AGENDA – Engineering and Construction Committee

- III. Report of Status of Operations and Construction
- IV. **Resolution R-66-25:** A Resolution Awarding a Contract for the Construction of the West Transmission Main along Book Road From 75th Street to the ComEd R.O.W. (Contract TW-6/25 Section 1 (Book Road))

DUPAGE WATER COMMISSION
WATERLINK EXTENSION
CONTRACT TW-6/25 SECTION 1 WEST TRANSMISSION MAIN

DRAWING NO. C-505	SHEET NO. 40 of 199

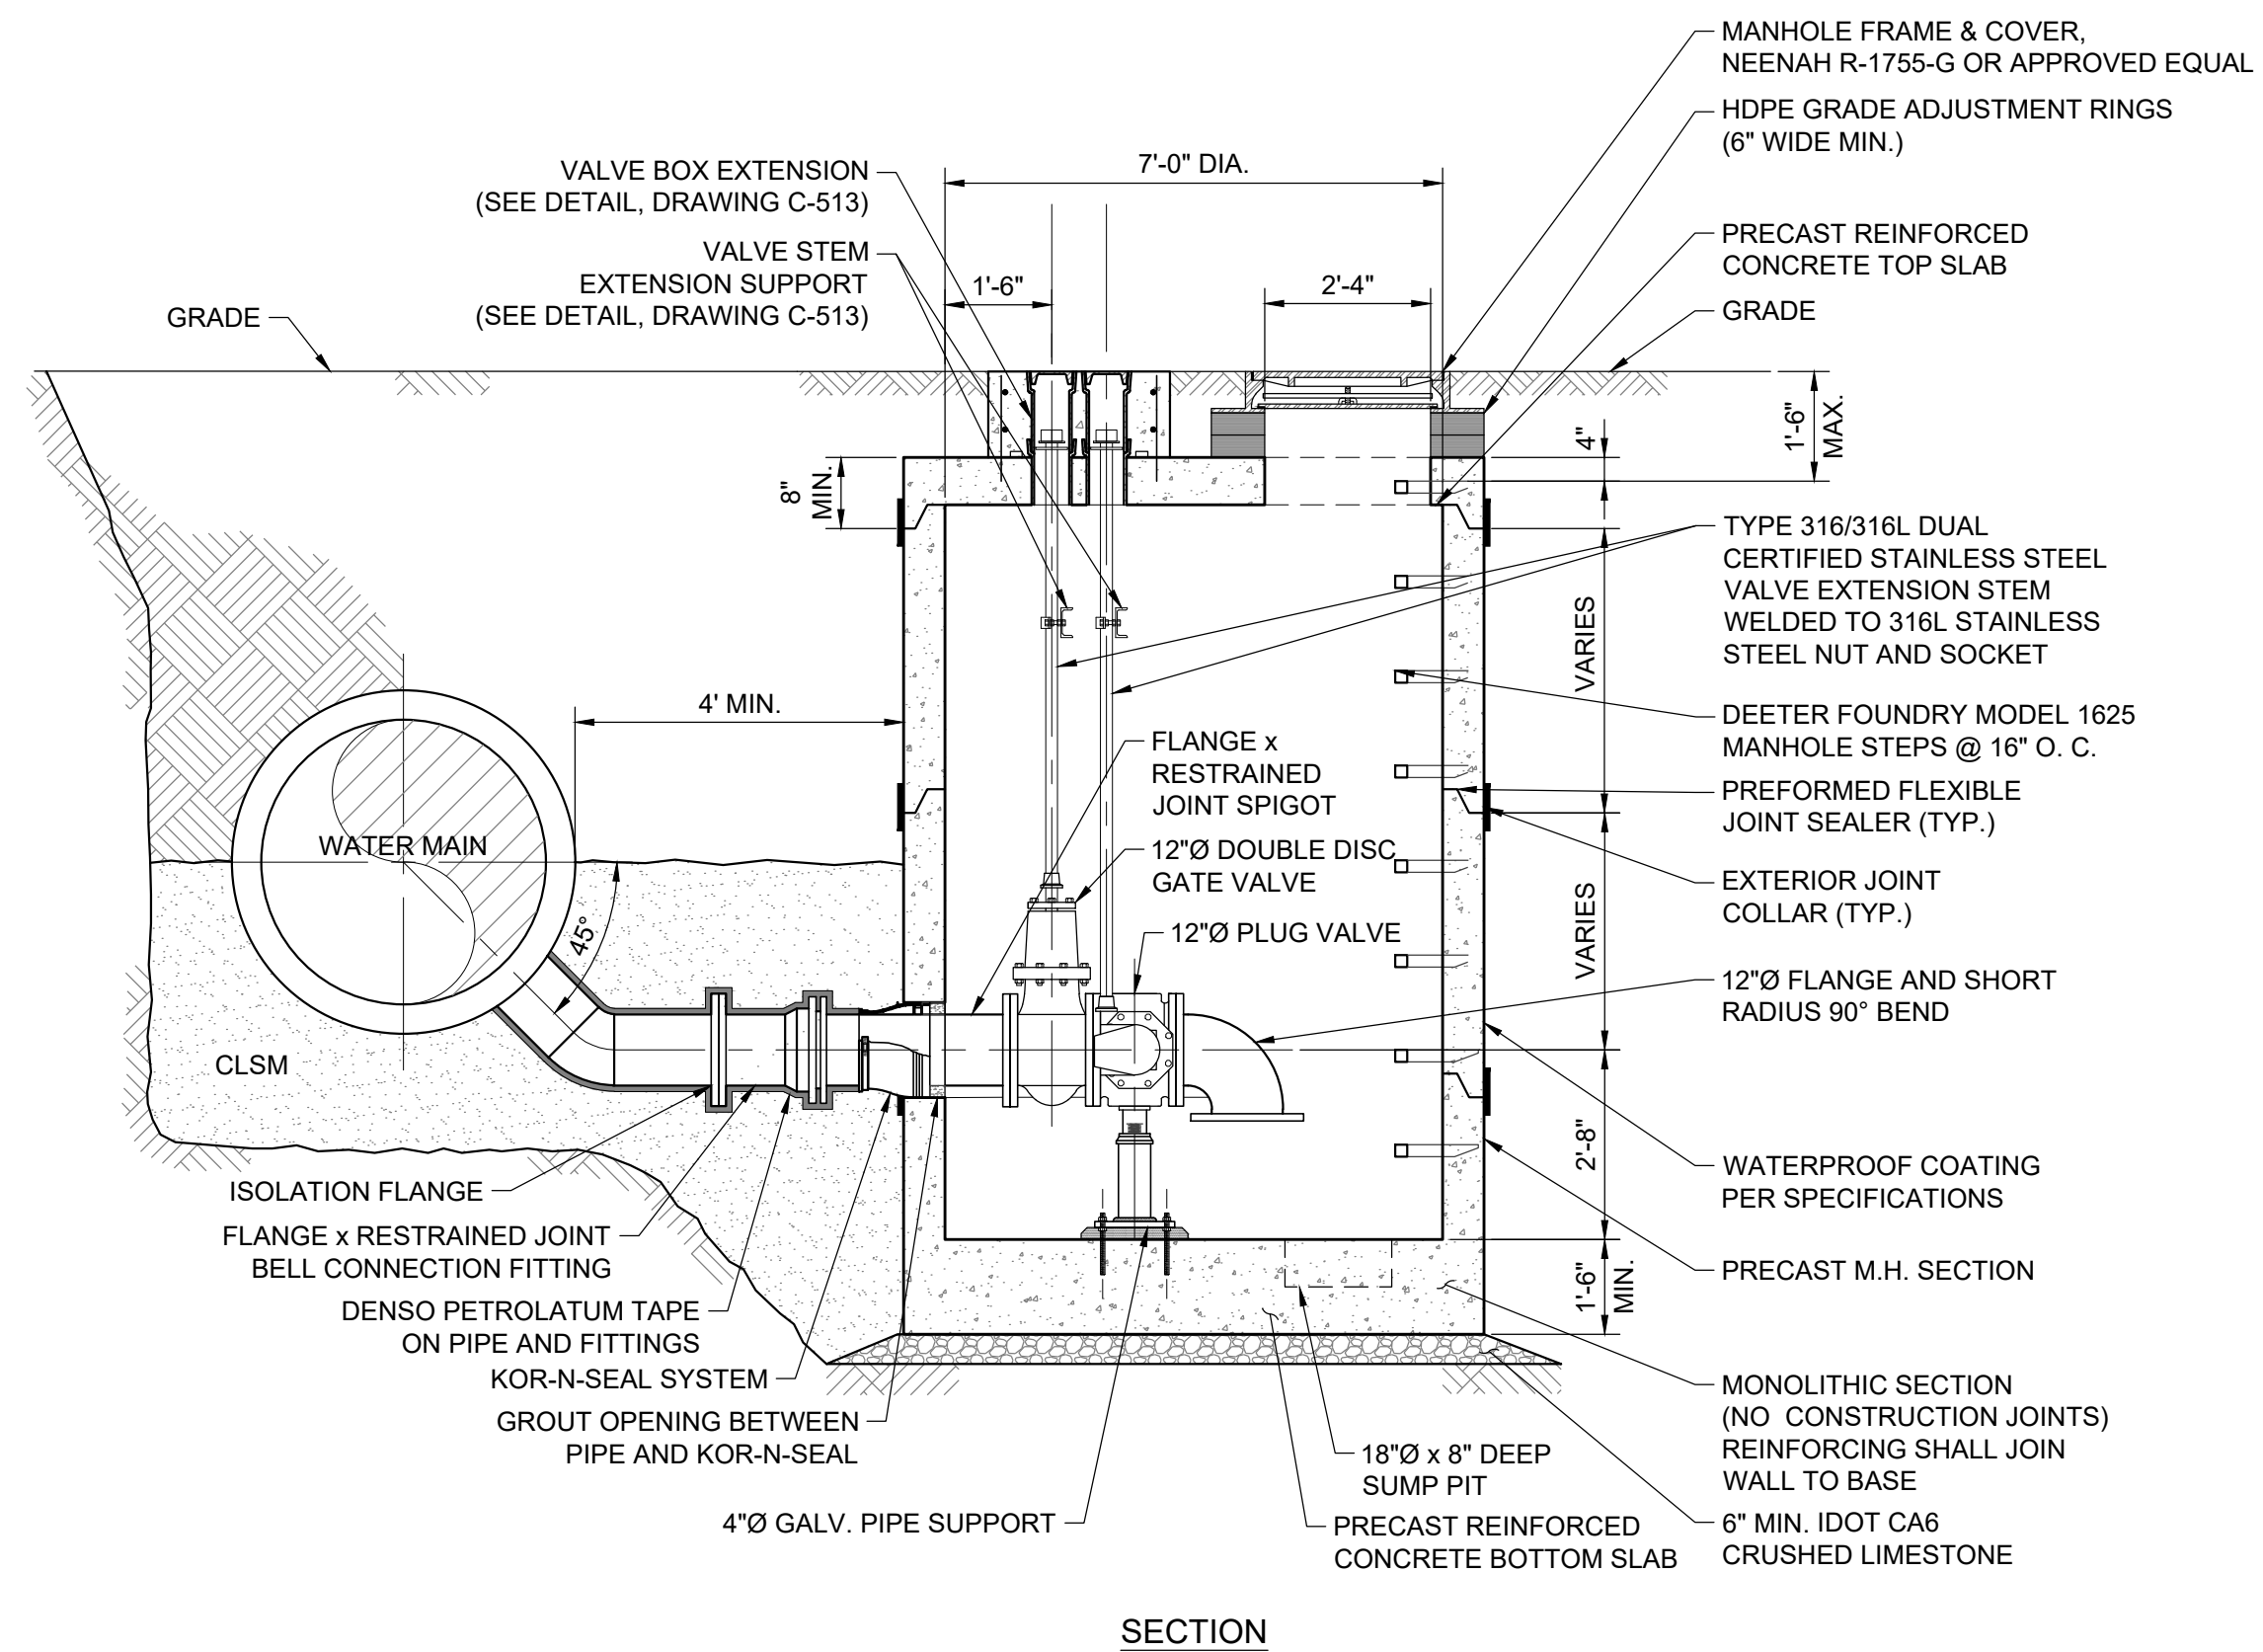
- K. Remove Sheet 35 of 199 (Drawing C-126) in its entirety and replace with the attached revised Sheet 35 of 199.
- L. Remove Sheet 40 of 199 (Drawing C-505) in its entirety and replace with the attached revised Sheet 40 of 199.
